TO THE PLANS AND SPECIFICATIONS

FARMER SCHOOL OF BUSINESS ROOF REPLACEMENT 2023

**Prepared for:
MIAMI UNIVERSITY
Hamilton, Ohio 45011**

**Elevar Design Group
555 Carr Street
Cincinnati, Ohio 45203
November 22, 2022**

TYPICAL FLASHING DETAIL @

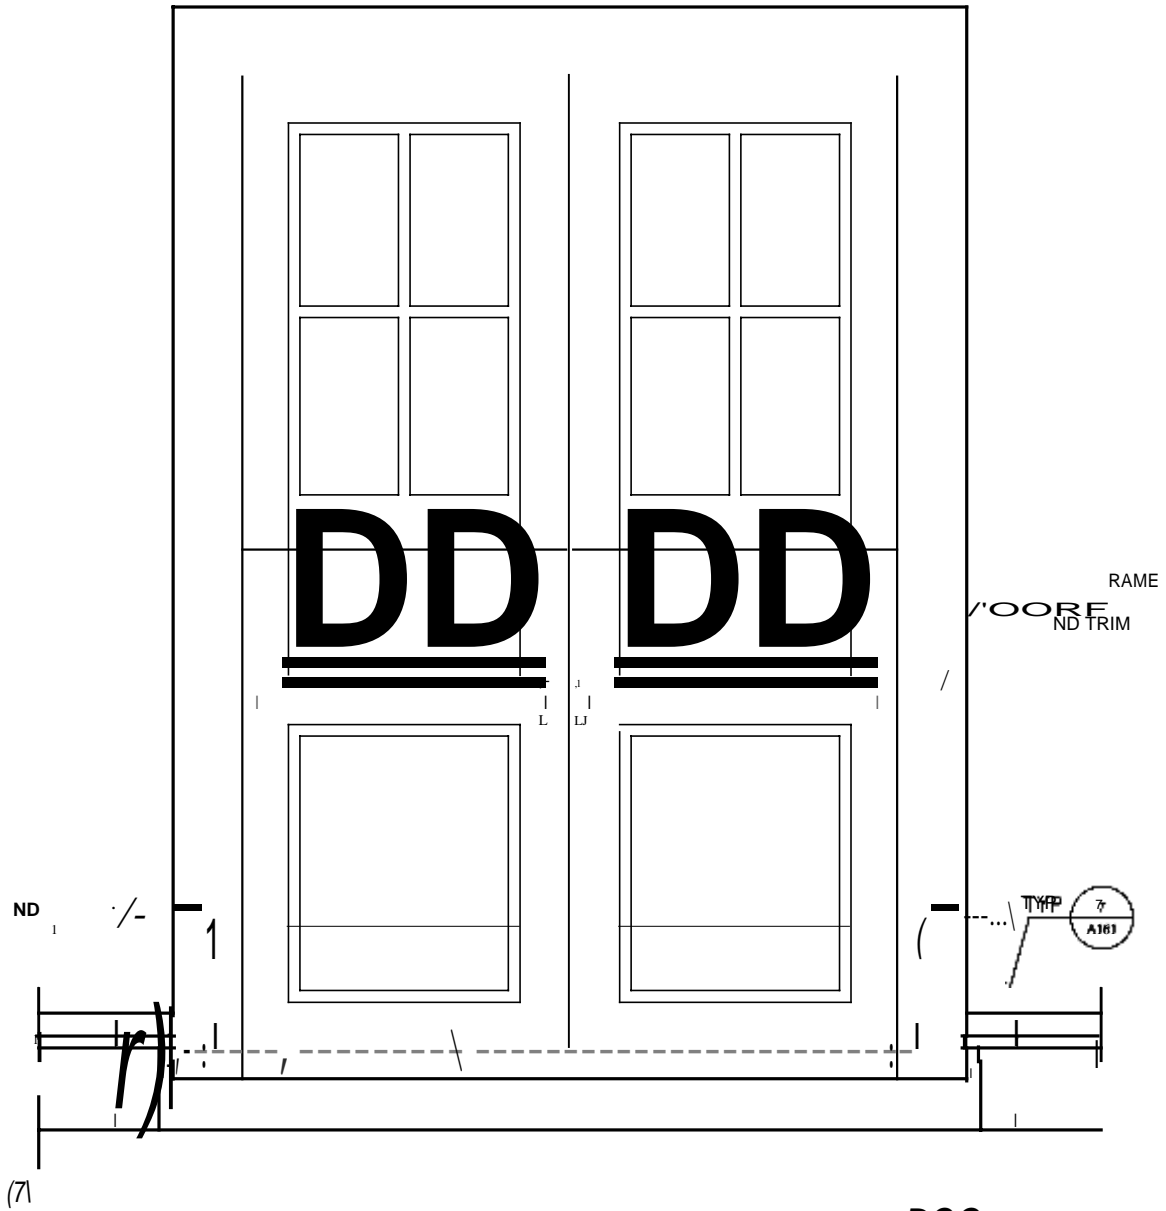
- A. Add the accompanying details to the drawing sheet.

1. 7/A161
2. 8/A161
